Re: Revision No. 6
Project Operations Plan
SCP Site Remedial Investigation
Carlstadt, New Jersey

**REVISED SCHEDULE
REMEDIAL INVESTIGATION RESAMPLING PROGRAM
AND ADDITIONAL SITE INVESTIGATIONS**

**SCP SITE
CARLSTADT, NEW JERSEY
BERGEN COUNTY, NEW JERSEY**

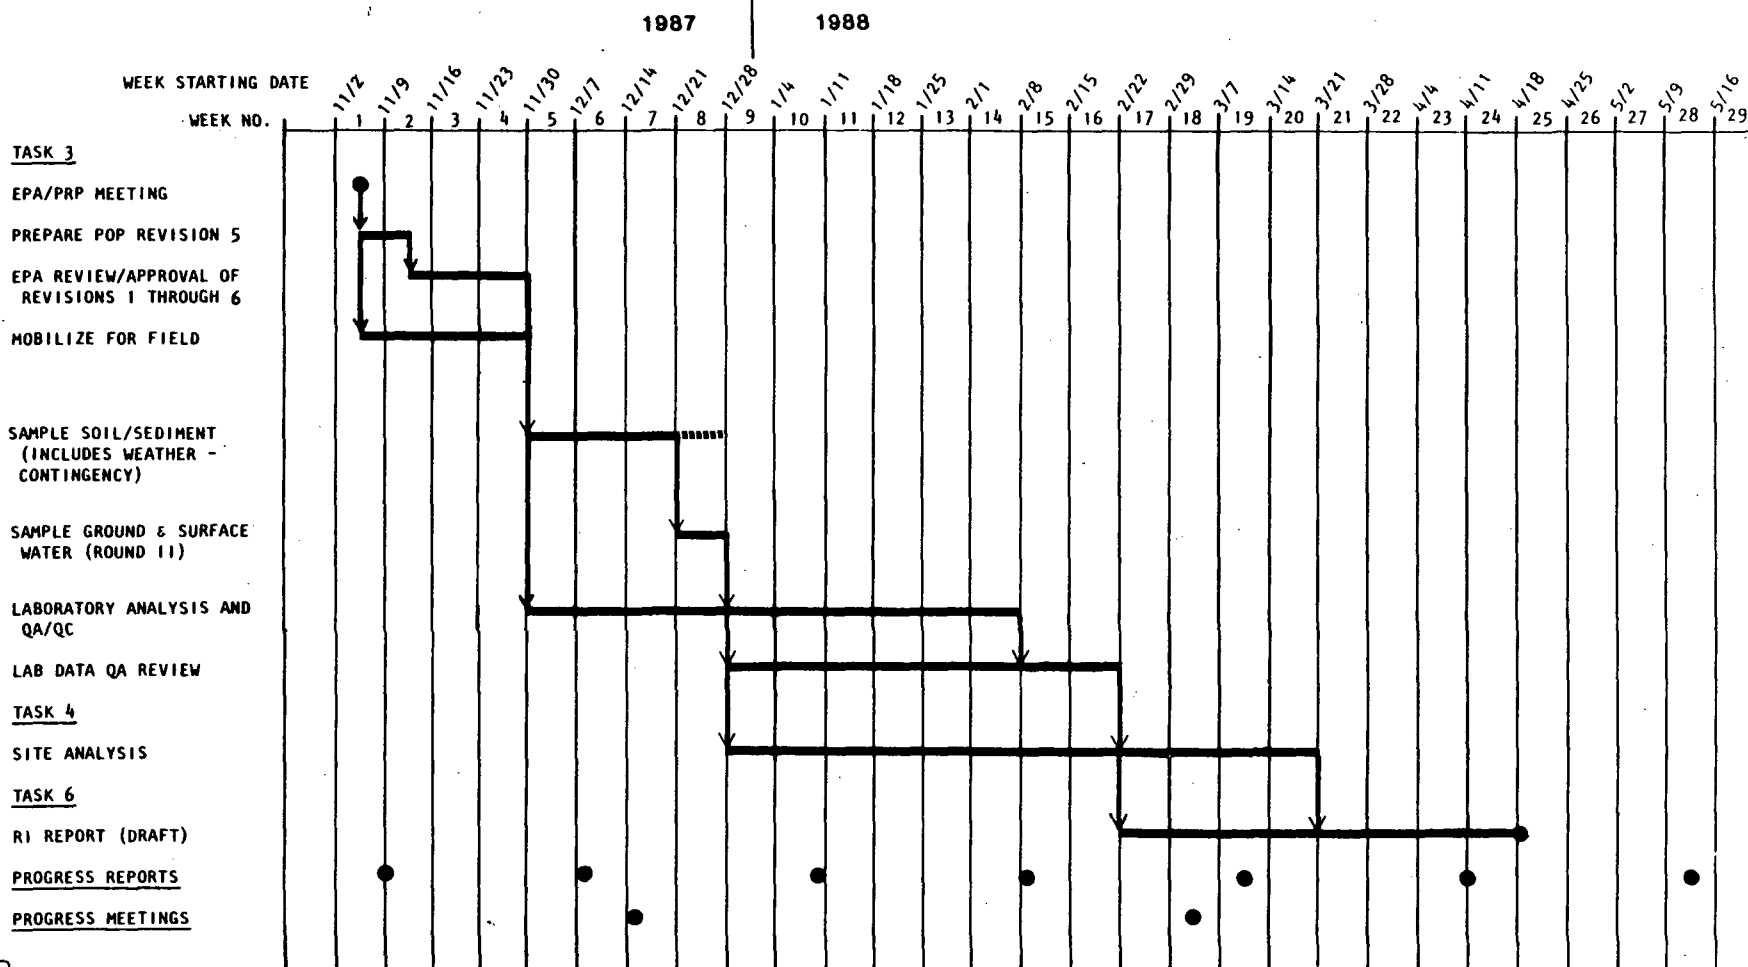
4. Figures 4-1 and 4-2: A revised schedule for the Remedial Investigation Phase of the project is attached. This schedule supercedes the schedule in Revision No. 5 to the POP dated November 11, 1987.
